Technical Service Bulletin - TBJ011

Date: October 6, 2009

Product: All R-22 units with TXVs

INSTRUCTIONS FOR TXV POWER HEAD REPLACEMENT

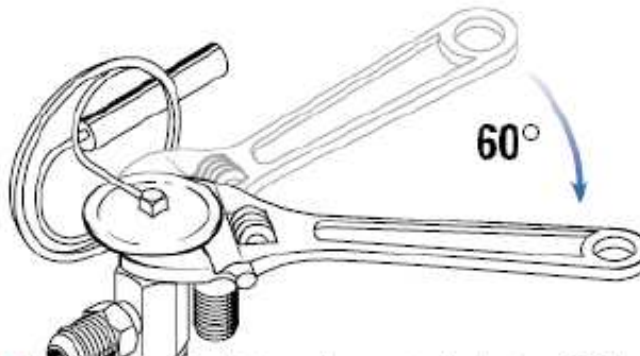
5 (Oil) Lubricate lock ring surface.

6 Hand tighten element.

7 After hand tight, turn element clockwise 60° (or movement equal to one hex flat).
